**DEVIATION REVIEW  
AND DECISION FORM**

**Monument Academy - Deviation No. 1**  
**Updated 8/14/2019**

Subdivision or Project Name: Monument Academy

**Monument Academy - Deviation No. 2**

FOR CONSTRUCTION

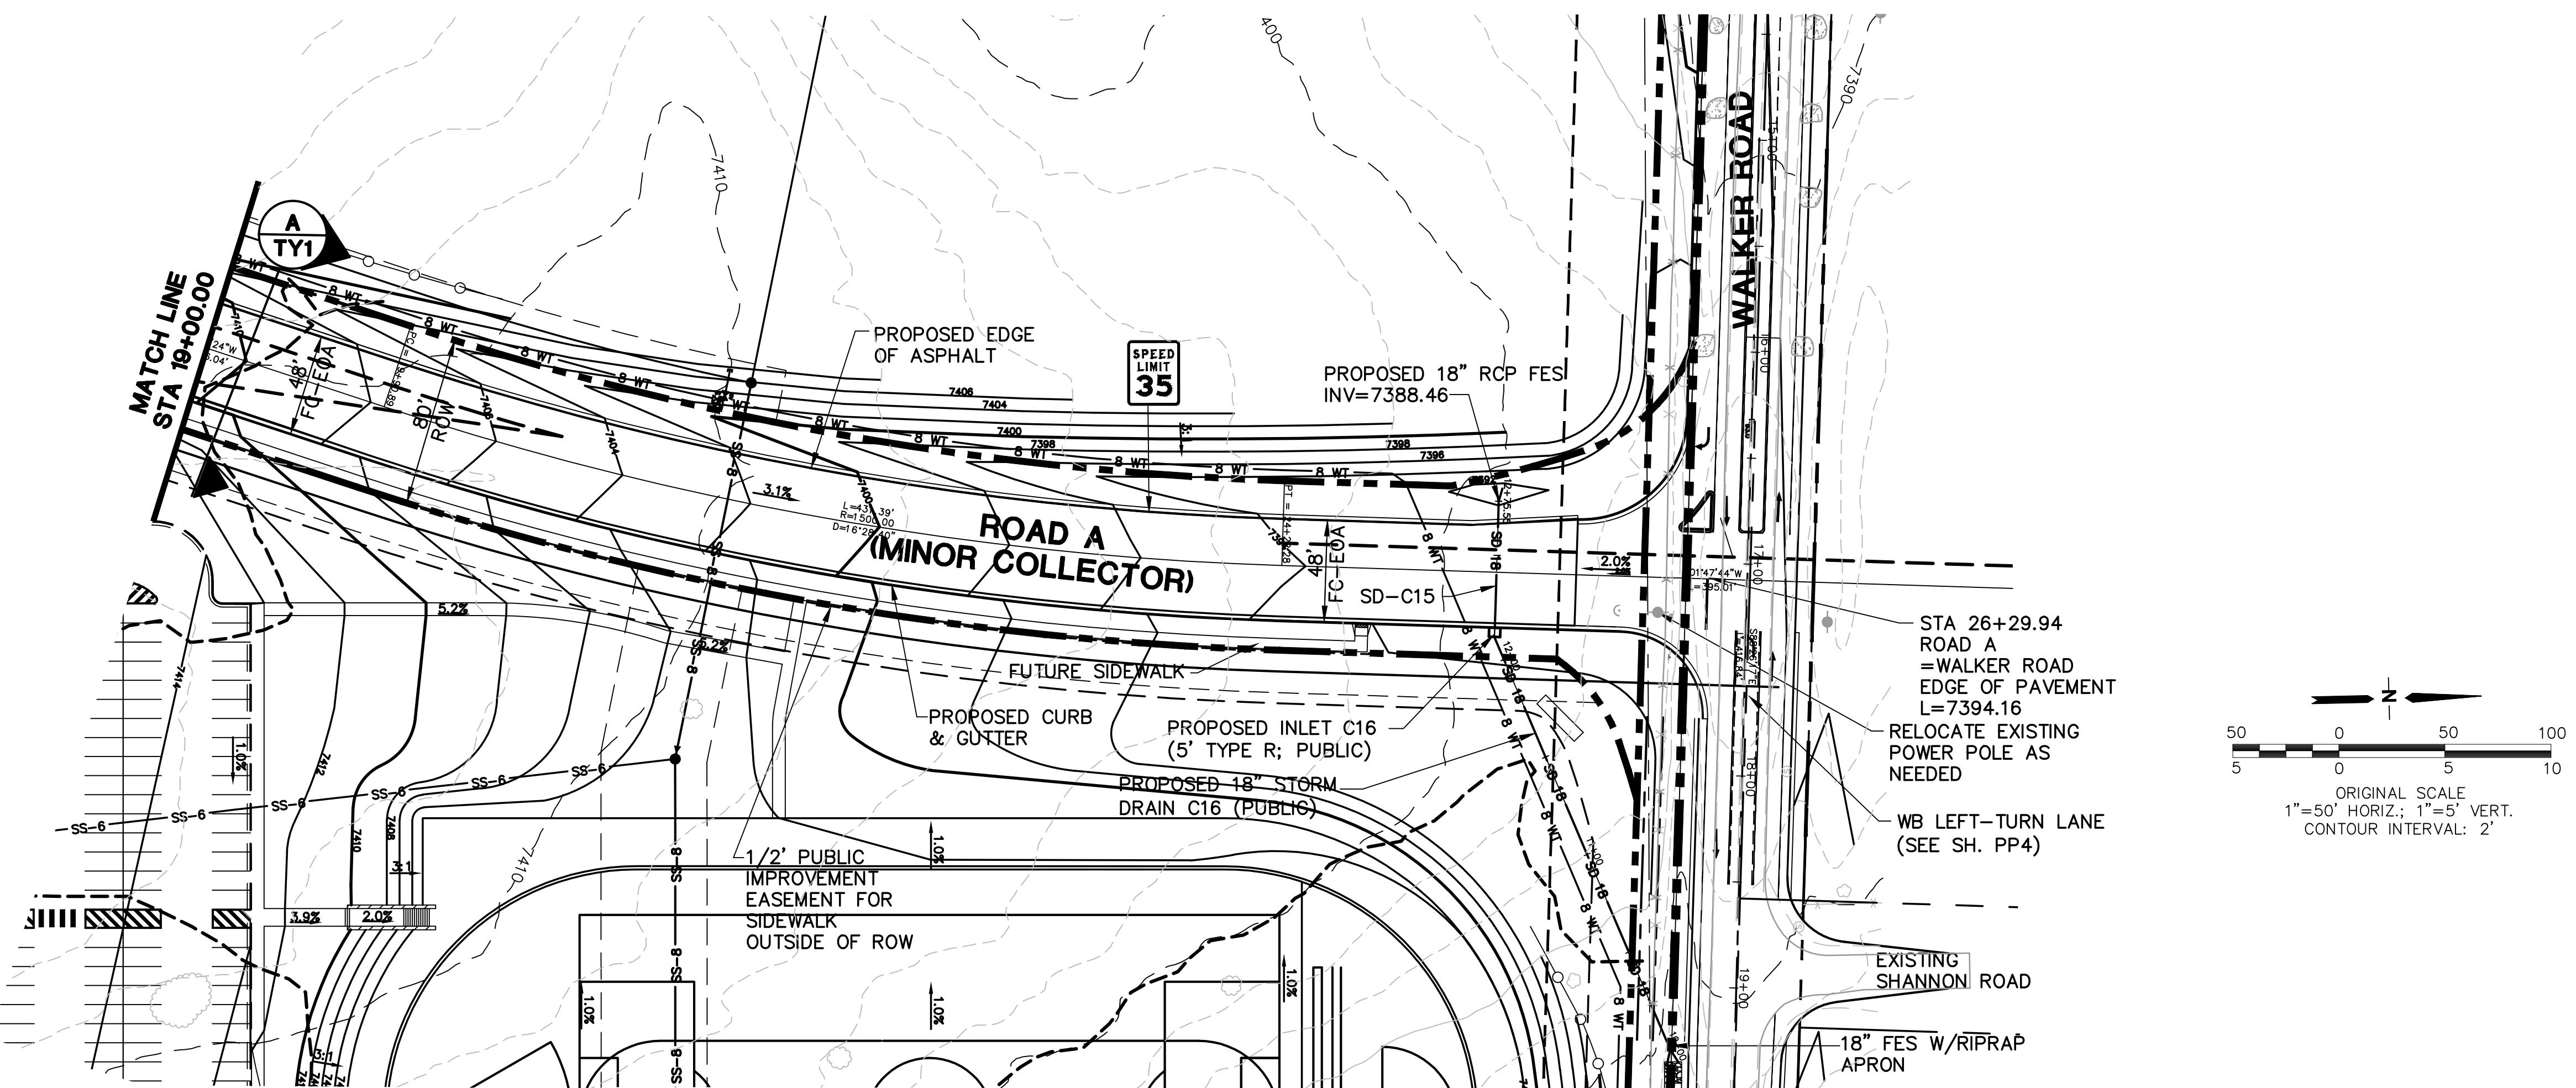
Specify when (all with first lot on west side? with subdivision?). Is the developer going to maintain the road until it is completed?

### Address traffic volumes - with the amount of traffic using the road (2,500 to 3,400 ADT), curb should be provided

**TYPICAL SECTIONS &  
DESIGN DATA -  
PINEHURST CIRCLE**

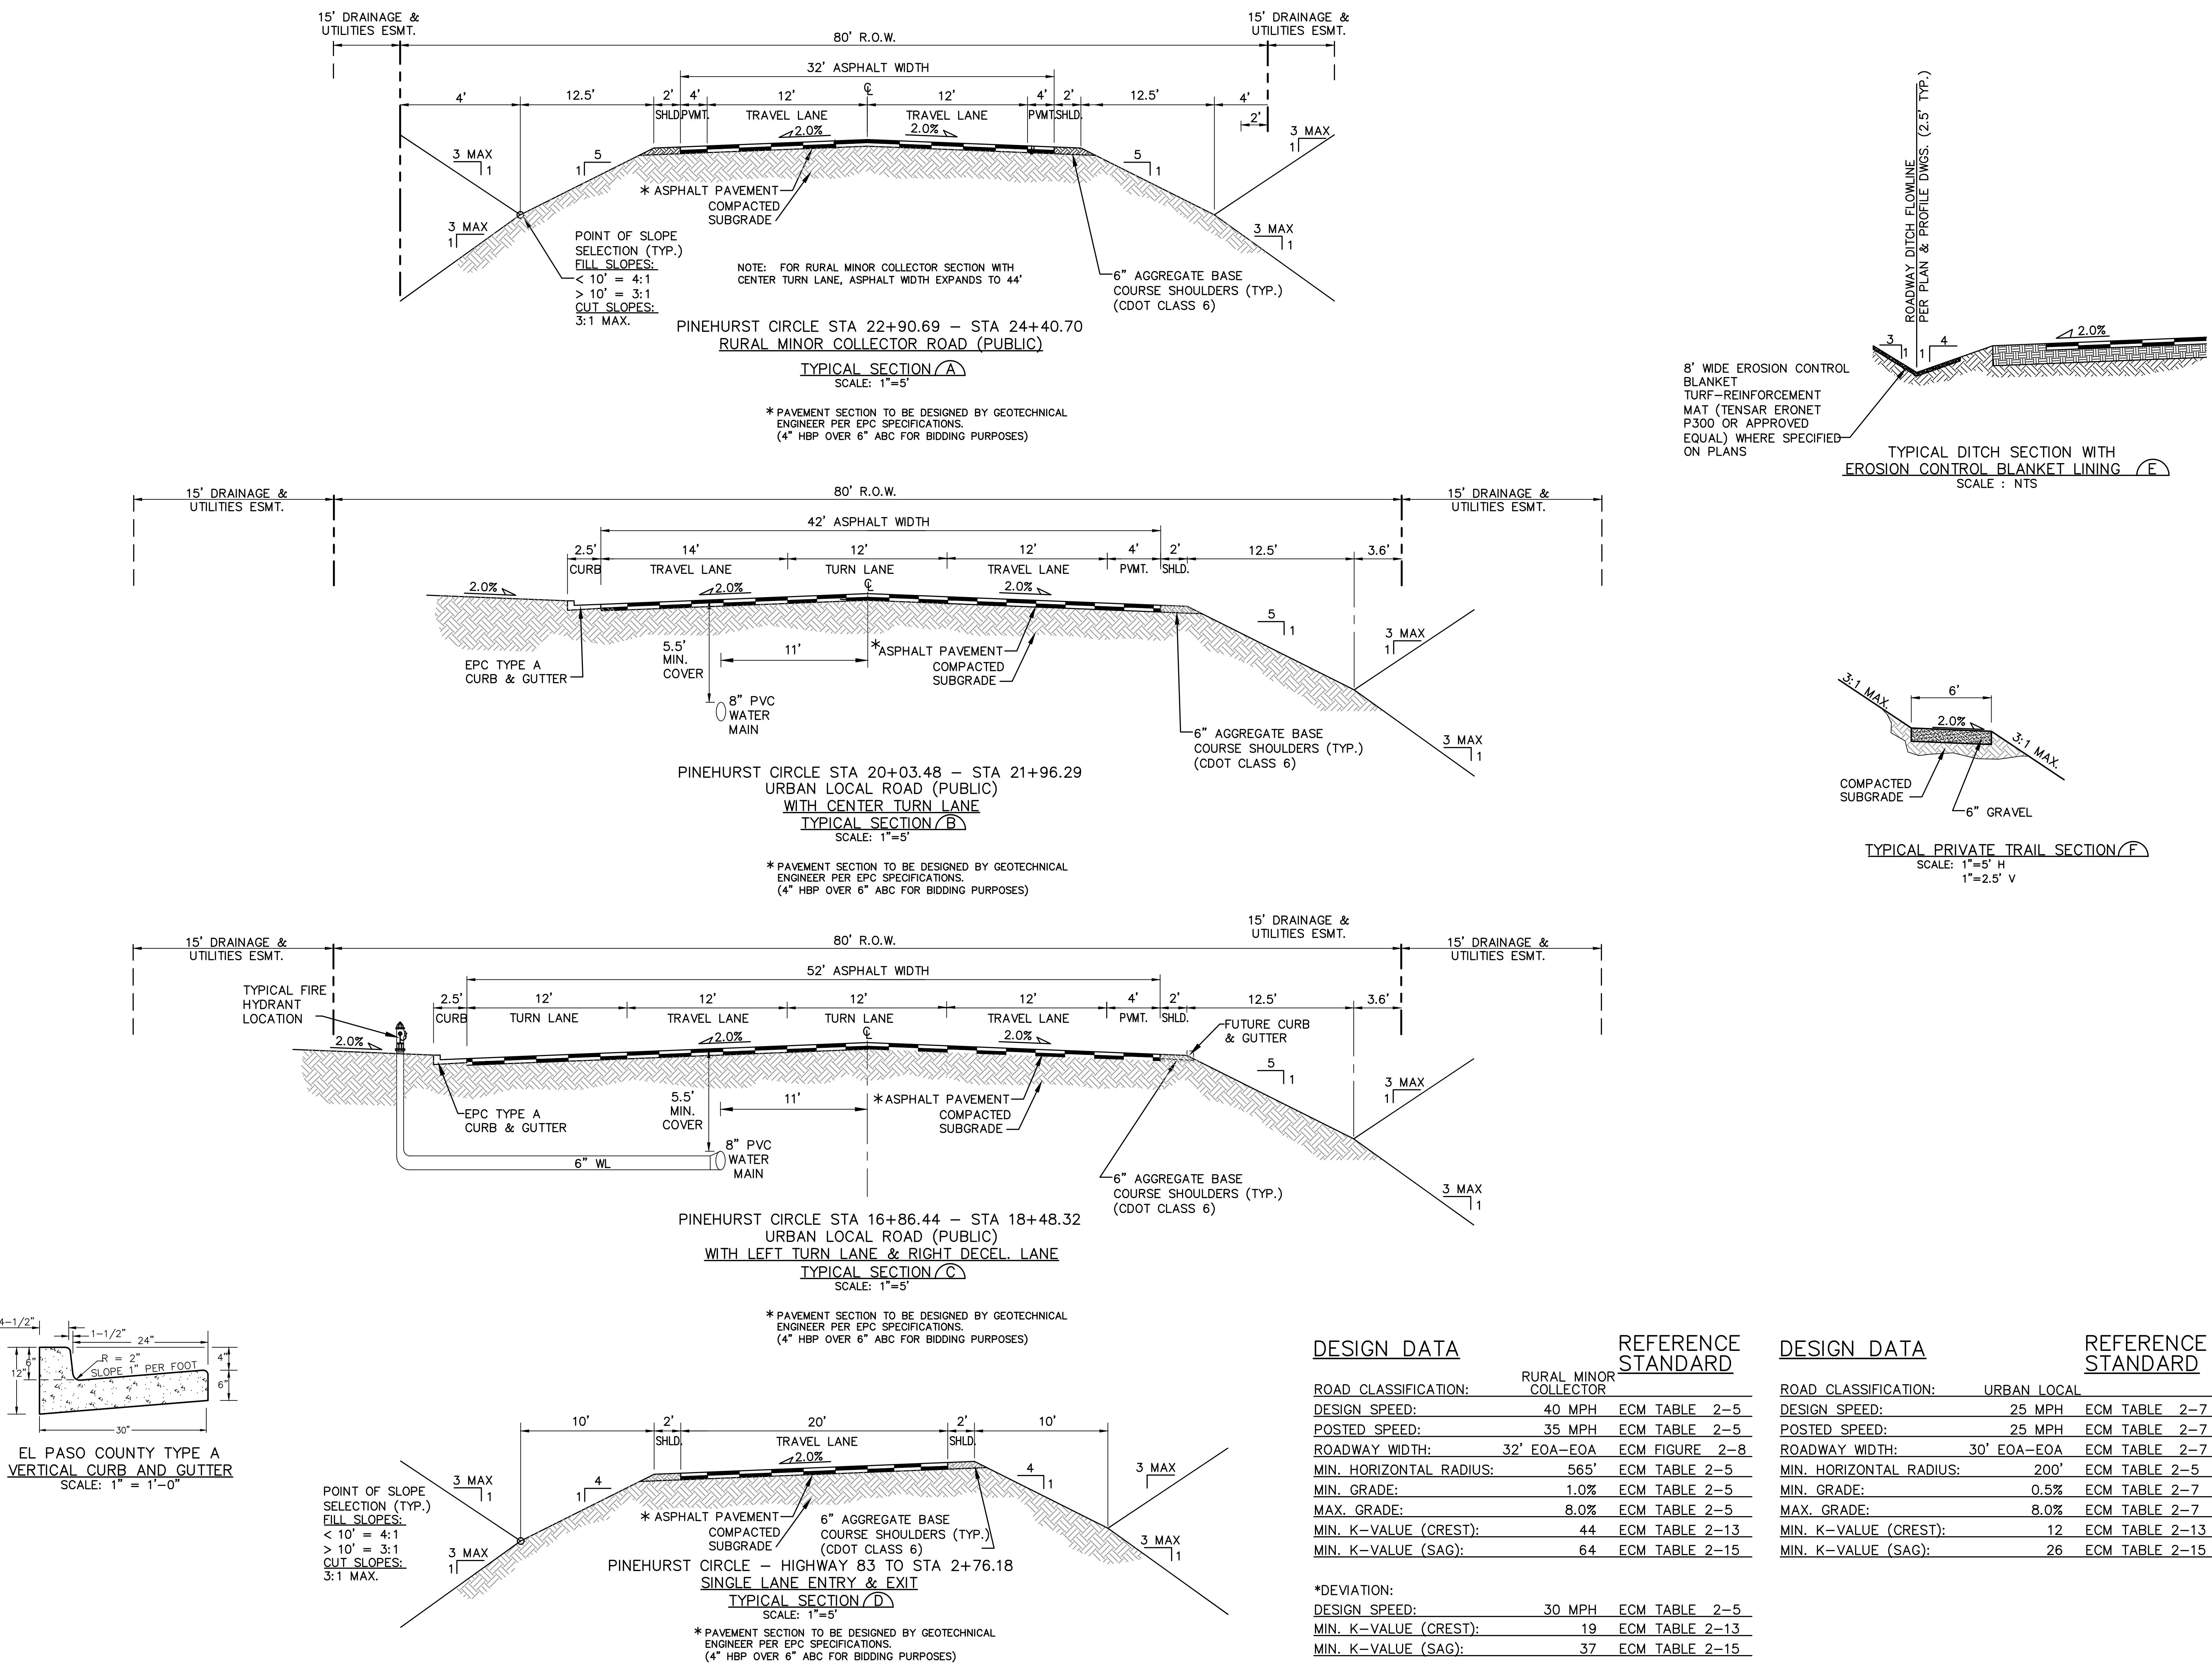
Shouldn't the portion from Road A to Highway 83 be an Urban Non-residential Collector based on ADT? See comment letter.
